# HISTORIC AND DESIGN REVIEW COMMISSION

**HDRC CASE NO:** 2019-322  
**ADDRESS:** 648 LEIGH ST  
**LEGAL DESCRIPTION:** NCB 2739 BLK LOT A15  
**ZONING:** R-5,H  
**CITY COUNCIL DIST.:** 1  
**DISTRICT:** Lavaca Historic District  
**APPLICANT:** JENNIFER BARRAR/BOBO CUSTOM BUILDERS  
**OWNER:** LATASHA DUNN/DUNN LATASHA  
**TYPE OF WORK:** Window replacement  
**APPLICATION RECEIVED:** July 19, 2019  
**60-DAY REVIEW:** September 17, 2019  
**CASE MANAGER:** Stephanie Phillips  
**REQUEST:**

The applicant is requesting a Certificate of Appropriateness for approval to replace seventeen (17) one over one wood windows with new wood windows. The applicant previously agreed to repair all the windows at the June 24, 2019, HDRC hearing, but has provided new evidence in an effort to substantiate the need for full replacement.

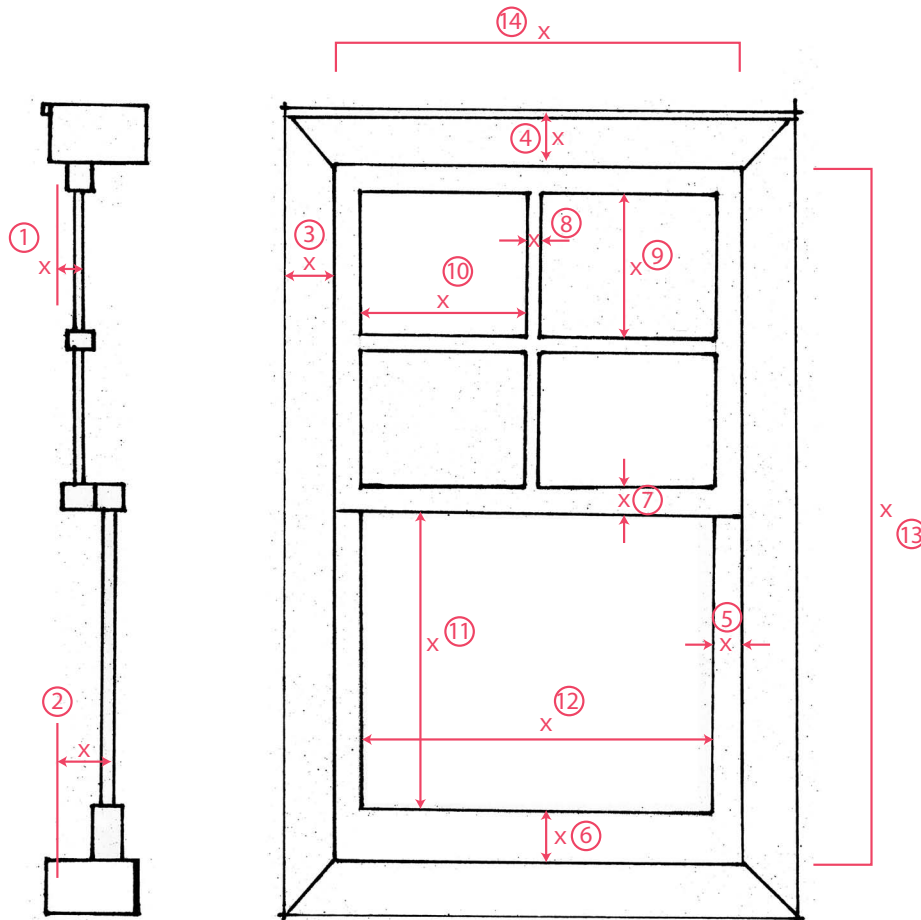
After observing the existing condition of the wood windows and associated elements, it is my opinion that proper window rehabilitation to yield adequate performance and proper service life is beyond reasonable cost.

- Deteriorated or missing sub-sill and sill boards;
- Soft, punky wood throughout jambs;
- Disjointed sash members, particularly at meeting rails; and
- Evidence of previous repairs executed incorrectly resulting in loss of original elements.

## WINDOW TYPE 1

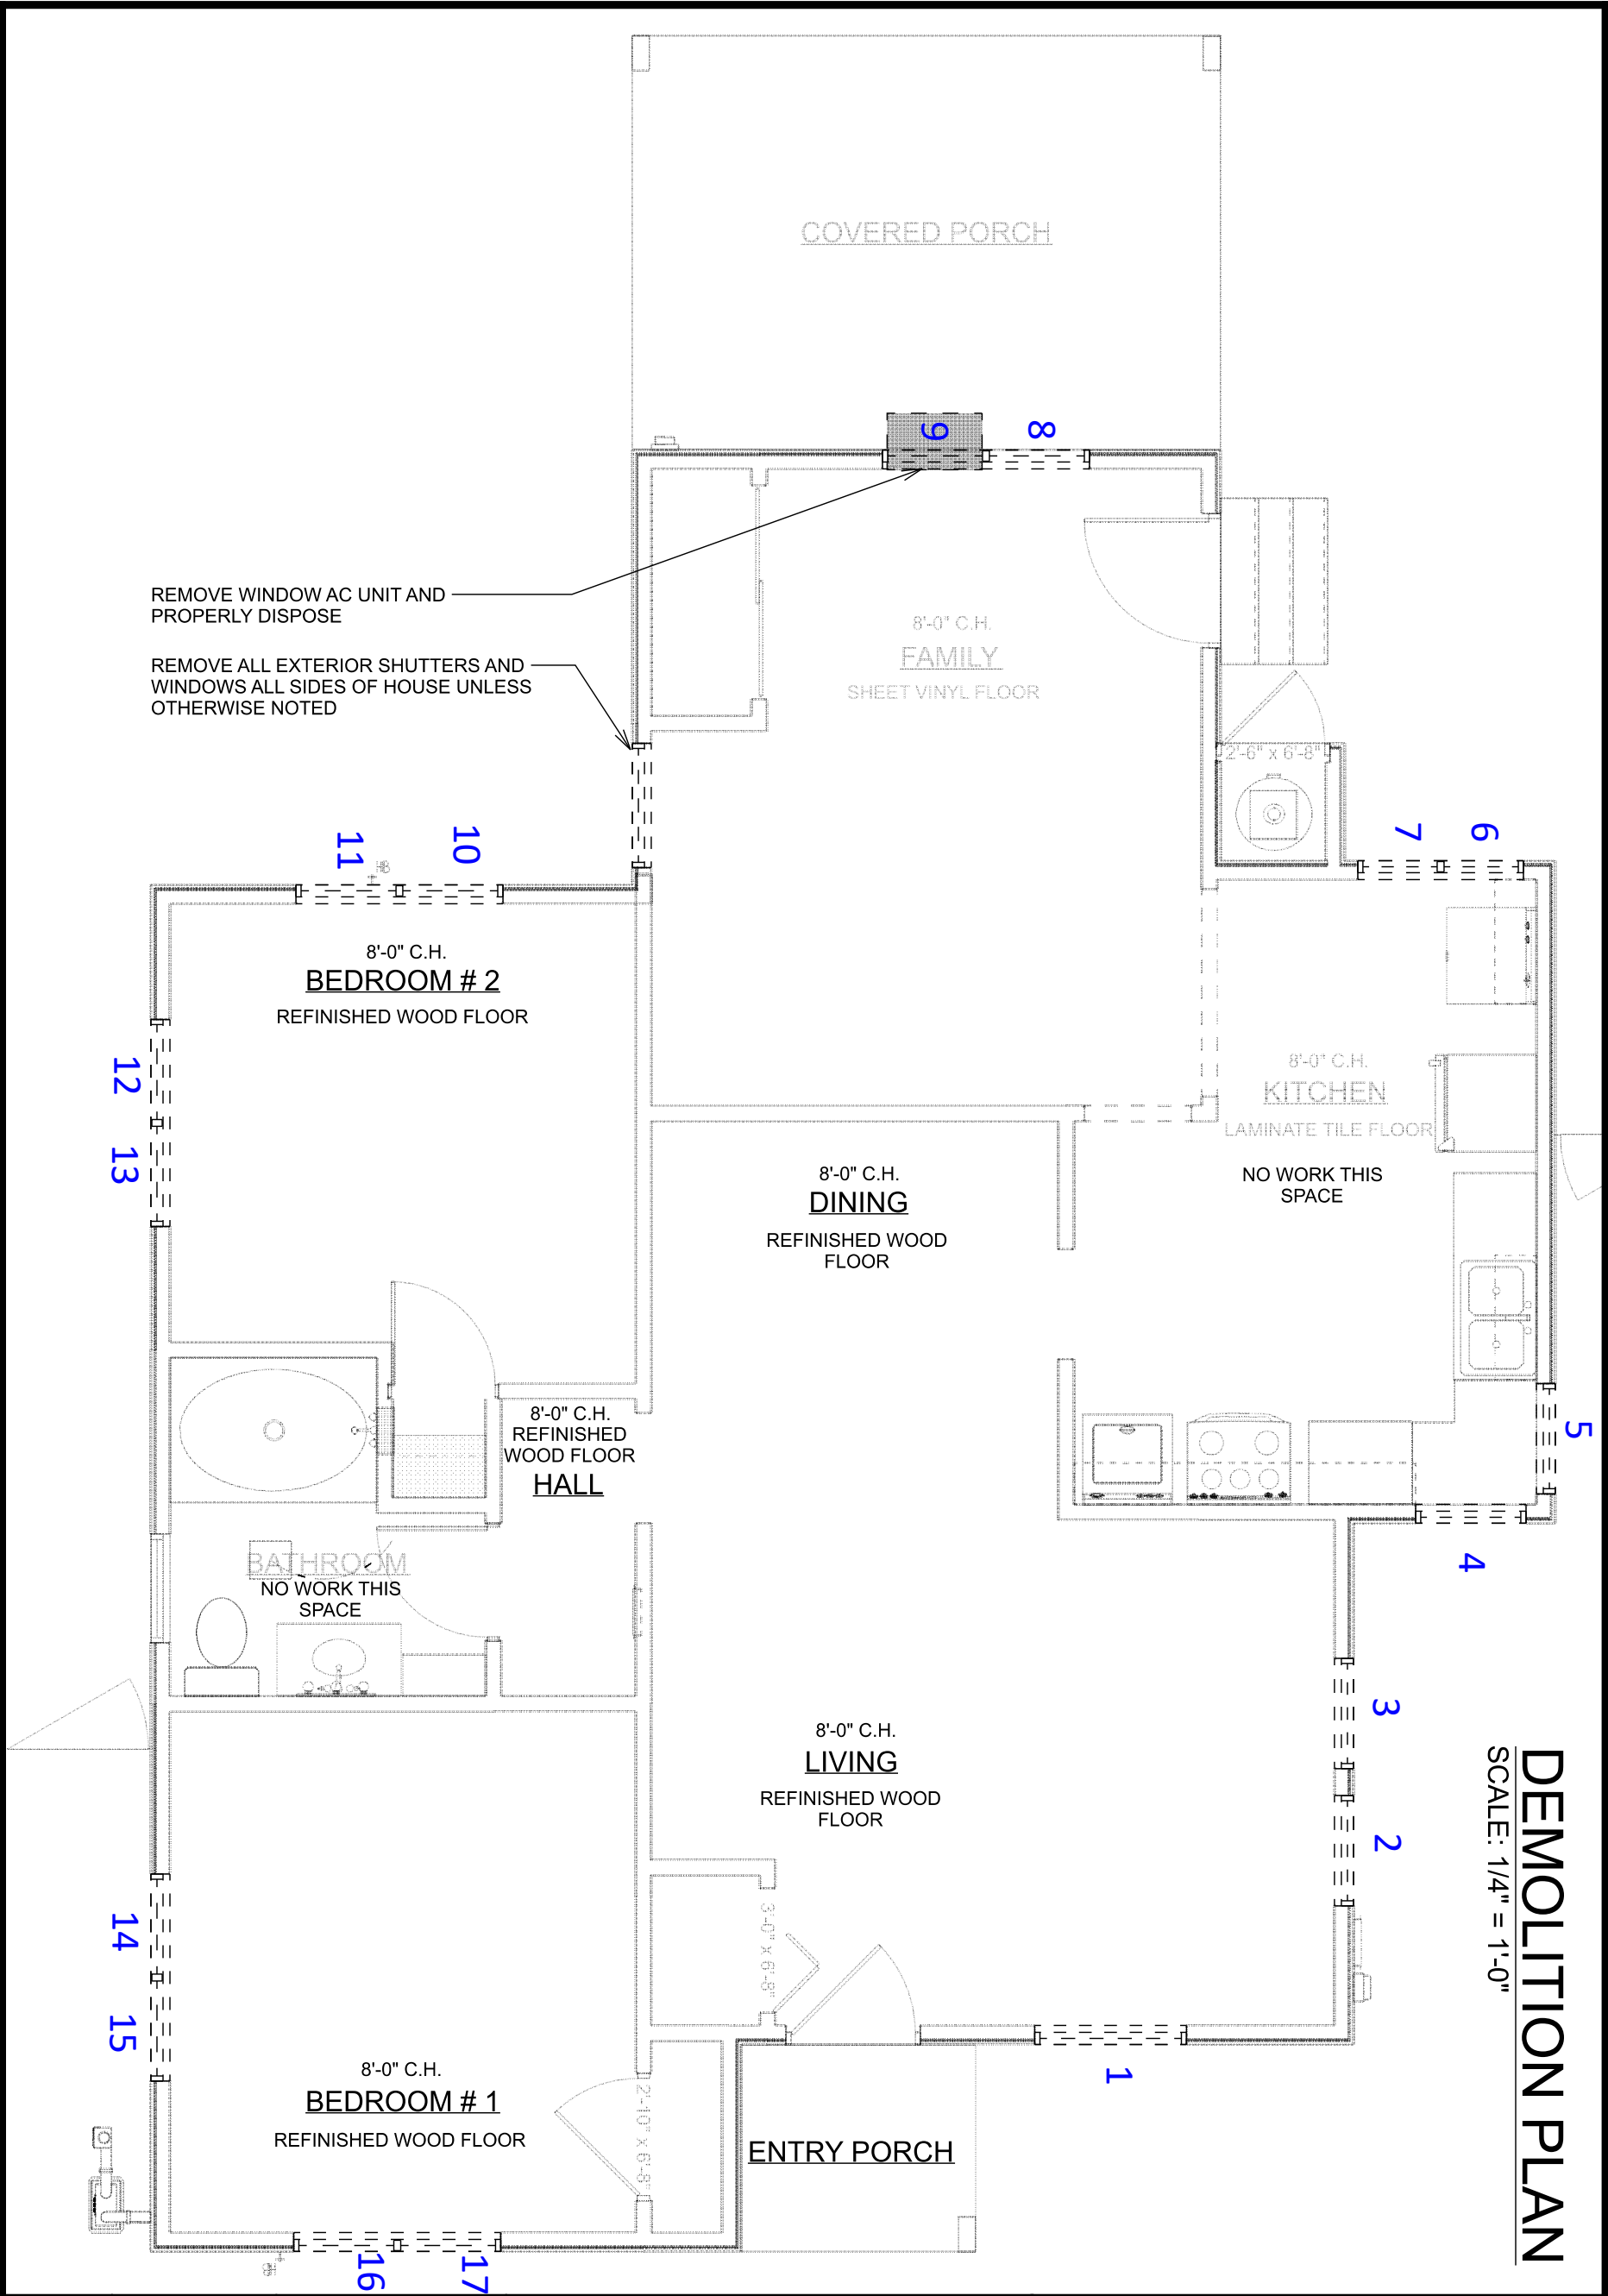
- f. **WINDOW REPLACEMENT** – According to the Guidelines for Exterior Maintenance and Alterations 6.A.iii., and 6.B.iv., in kind replacement of windows is only appropriate when the original windows are beyond repair. Based on the new information provided, staff finds one window, labeled window 11 on the submitted floor plan, to be unrepairable. Replacement of additional windows is not consistent with the Guidelines based on the evidence provided.

- i. That the applicant installs one-over-one fully wood windows to match the existing configuration as closely as possible. Meeting rails must be no taller than 1.25" and stiles no wider than 2.25". There should be a minimum of two inches in depth between the front face of the window trim and the front face of the top window sash. This must be accomplished by recessing the window sufficiently within the opening or with the installation of additional window trim to add thickness. The final specification should be submitted to staff for review prior to the issuance of a Certificate of Appropriateness.
